TOWN OF WELLS, MAINE
PLANNING BOARD

Meeting Agenda
Monday, February 23, 2026, 7:00 PM
Littlefield Meeting Room, Town Hall
208 Sanford Road

VI. **526 POST ROAD**

SHEET C-104

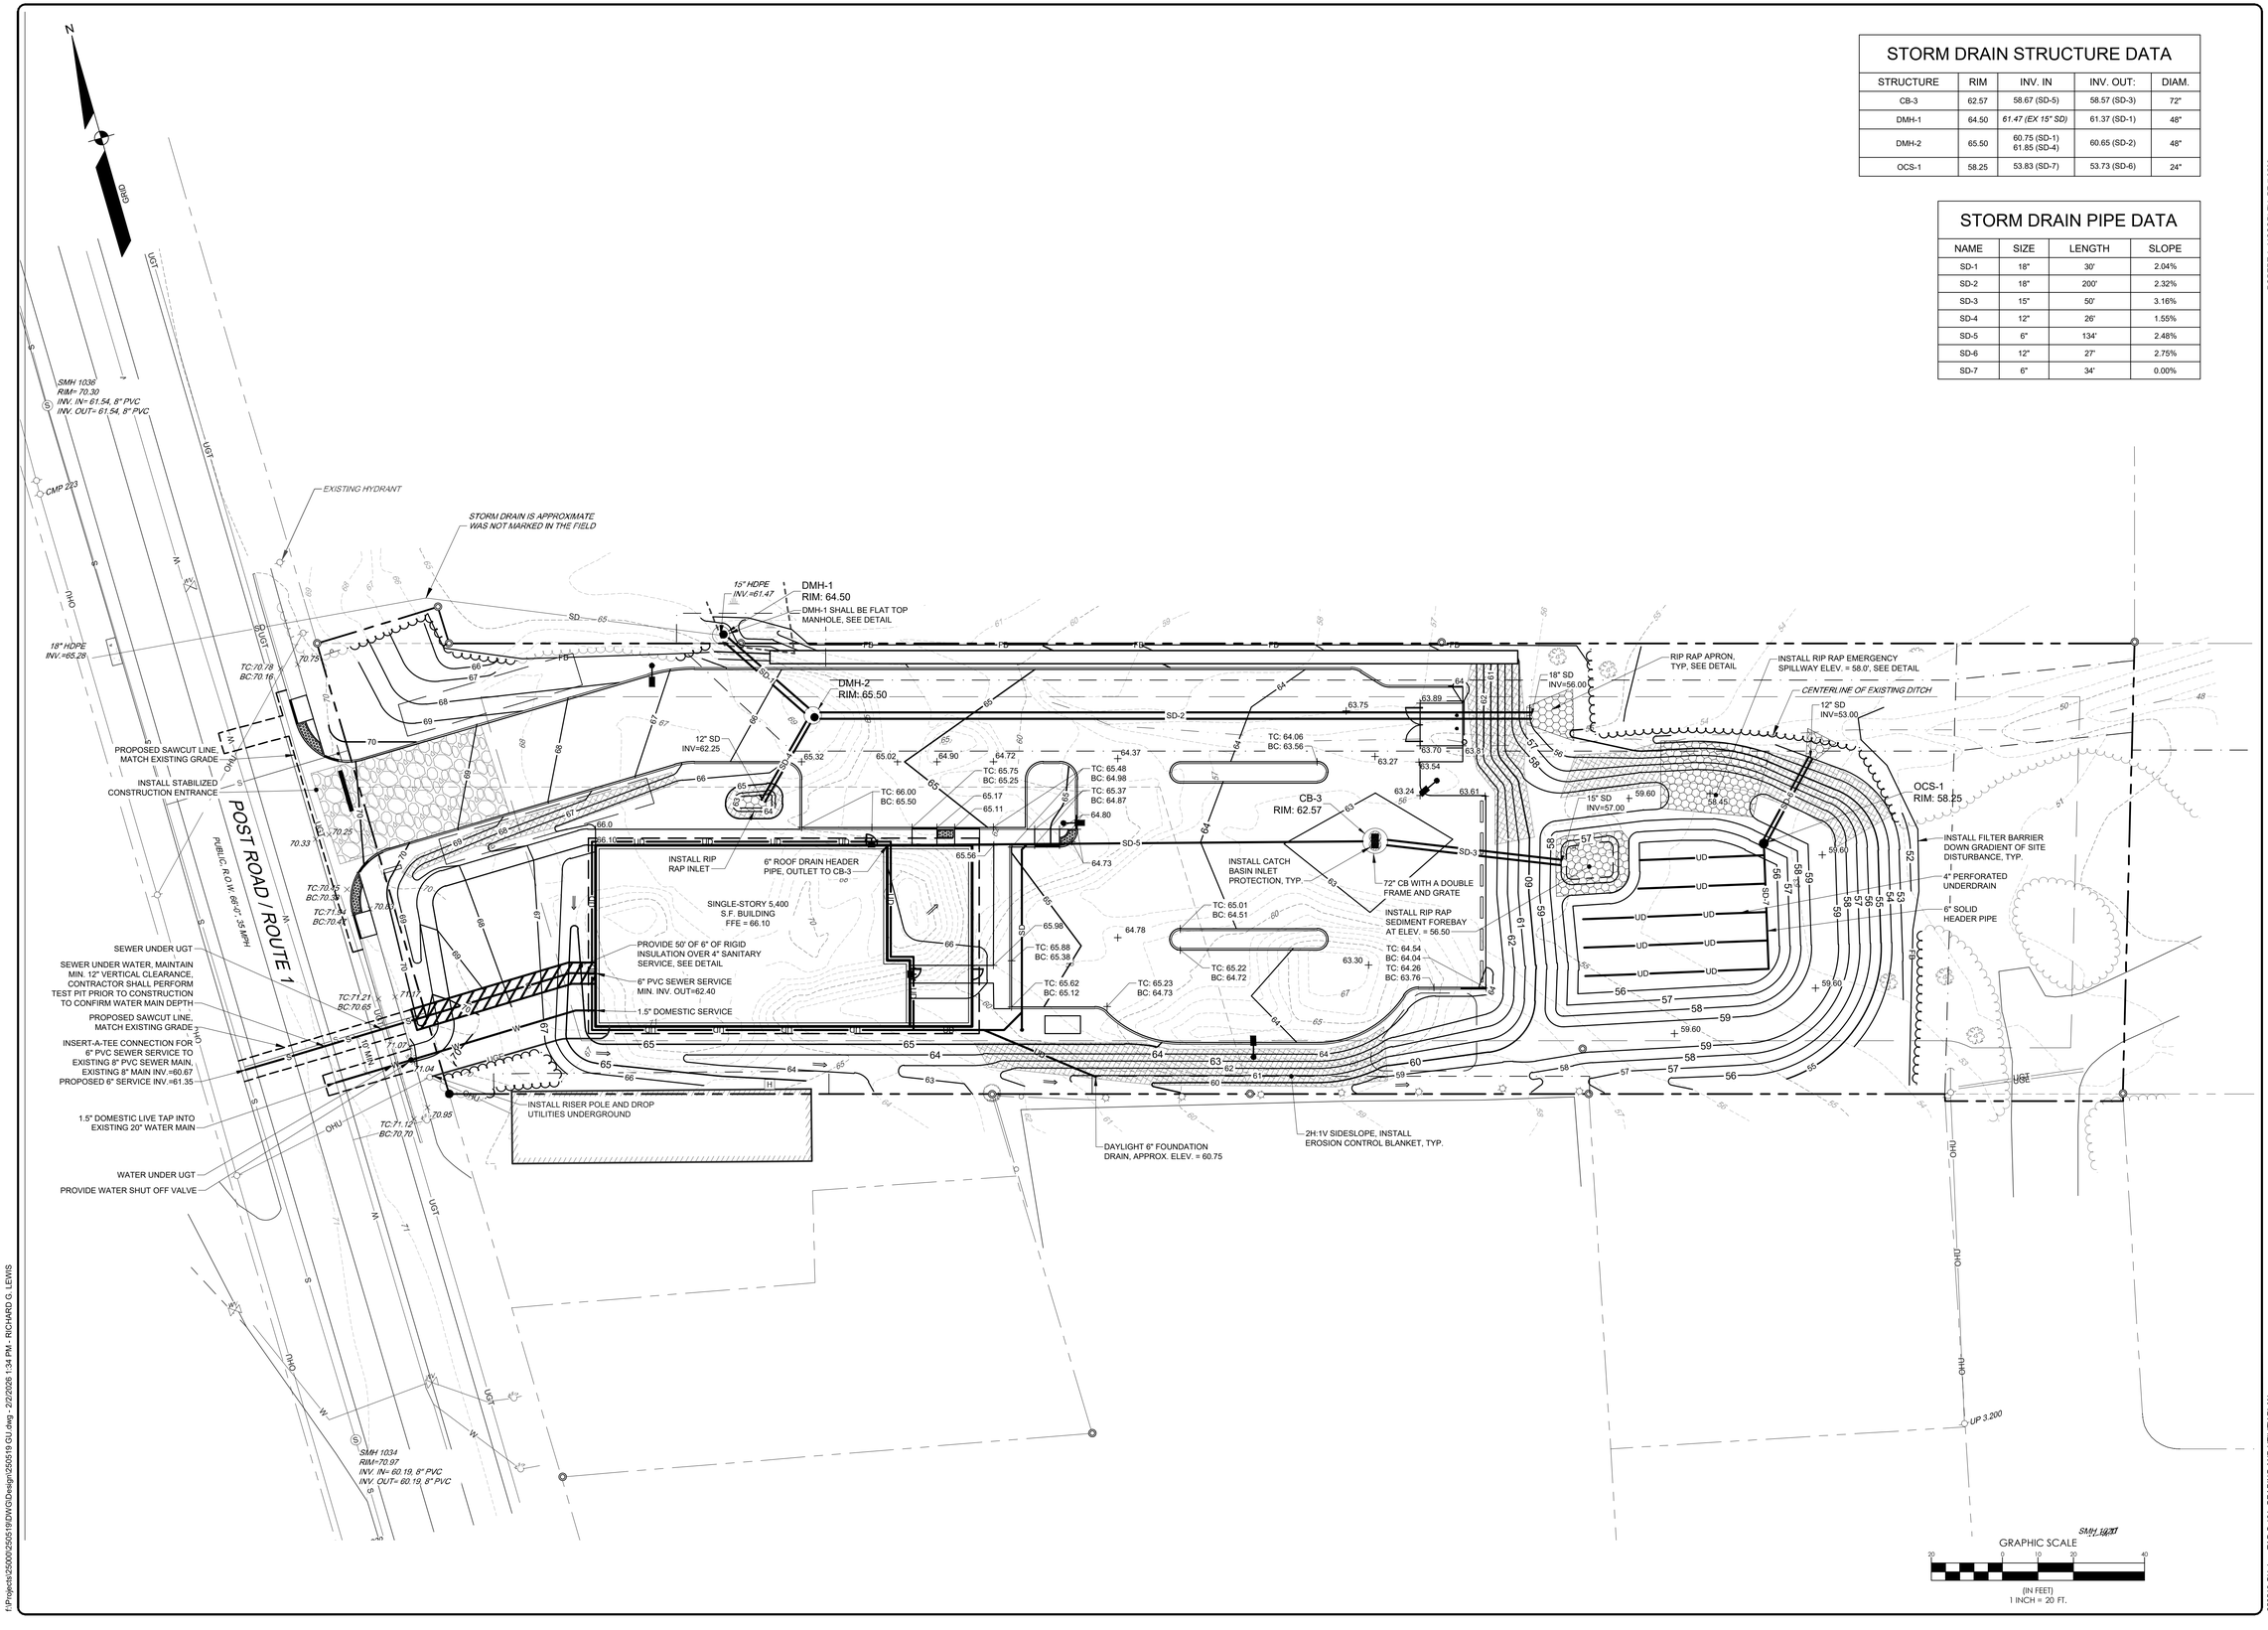
(9)	All existing contours and proposed finished grade elevations of the portions of the site which will be altered and the system of drainage proposed to be constructed. Contour intervals shall be specified by the reviewing authority. This requirement may be waived by the reviewing authority if no additional lot coverage is proposed or the proposed lot coverage is less than 30% and has an area of less than 15,000 square feet.	**Y**				Existing and proposed one foot property contours are shown on sheet C-104.
